Staff Report

To: Salt Lake City Historic Landmark Commission
From: Amy Thompson, Principal Planner
801-535-7281 or amy.thompson@slcgov.com
Date: January 5, 2017
Re: **New Construction -PLNHLC2016-00771**
Special Exception-PLNHLC2016-00925

NEW CONSTRUCTION – APARTMENT BUILDING

PROPERTY ADDRESS: 35 South 900 East

3 TYPICAL WINDOW HEAD AT STUCCO
A200 3" = 1'-0"

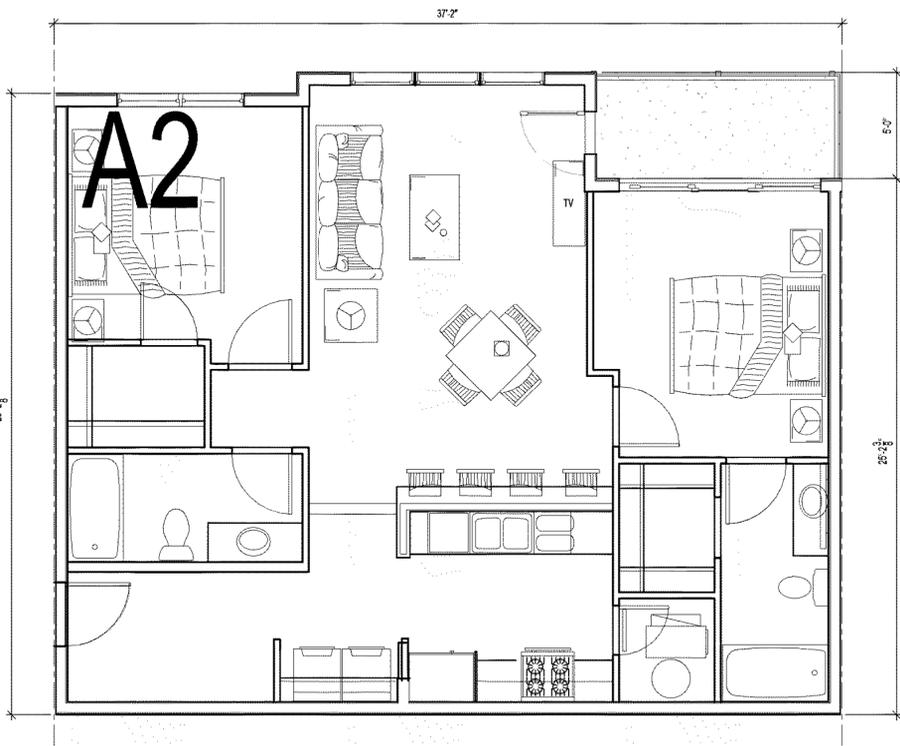
1. A window section with window detail and measurements and information about each window type proposed (single hung, casement etc.)
2. Floor plans that also demonstrate how much the building wall steps in on the facade. Indicate measurements/building articulation

EXTERIOR ELEVATIONS

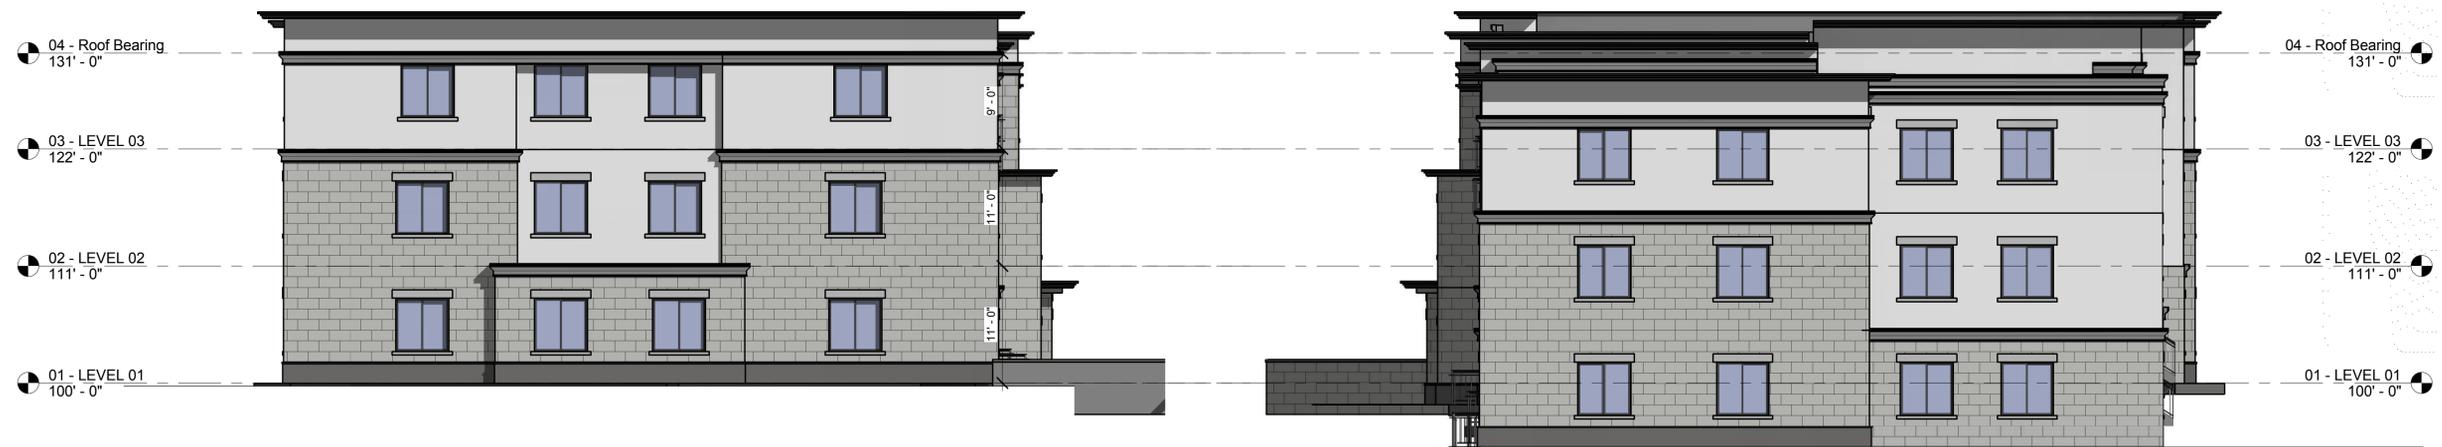
3. More pushing and pulling to break up facades
 - a. We have put a 6" step between the "units" in an effort to break up the façade. We are limited by the setbacks, parking and landscape buffers on the site and cannot add larger steps in the footprint. The 6" step allows us to wrap materials and terminate materials in an appropriate manner.

2 Window Elevation Enlarged
A303 3/4" = 1'-0"

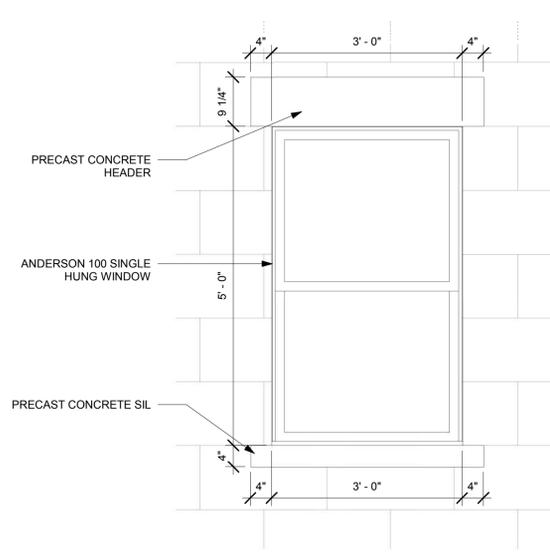
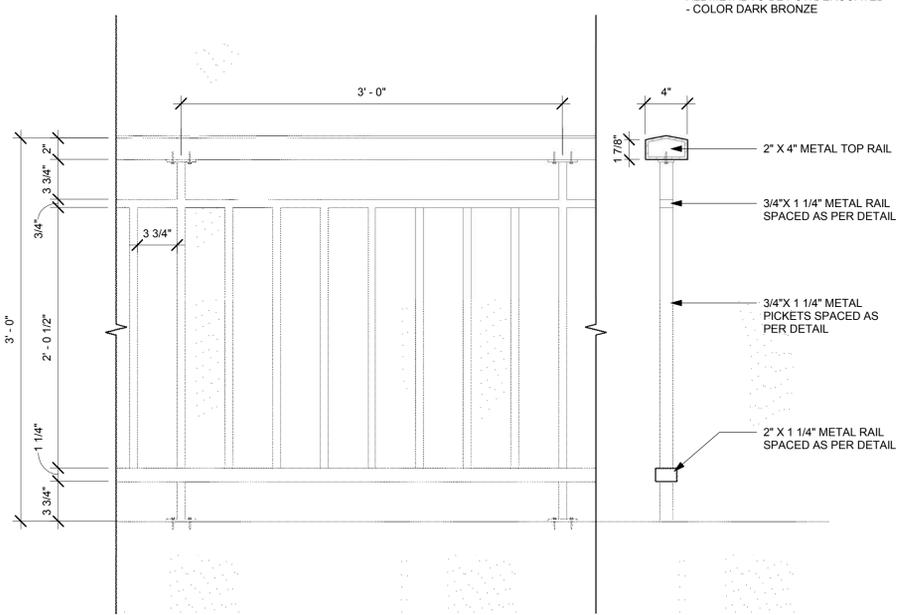
- a. We have modified the windows on the west elevation and added two double hung windows in place of one larger slider window.
13. Casements are better than sliders, double hung look better than casements. Traditional suburban windows are not appropriate in this setting.

Response - Our windows on the primary (west) façade have been designed to reflect the proportion of nearby buildings. We have incorporated single hung windows along the historically visible streetscape (900 E).

Response - The fenestration pattern reflects the historical character of nearby buildings. Our windows will be recessed from the face of the primary façade by min 2”.

Response – The windows are setback from the building face, creating a relief and texture as seen in similar buildings and homes in the area. The windows will NOT be flush with the façade of the building.
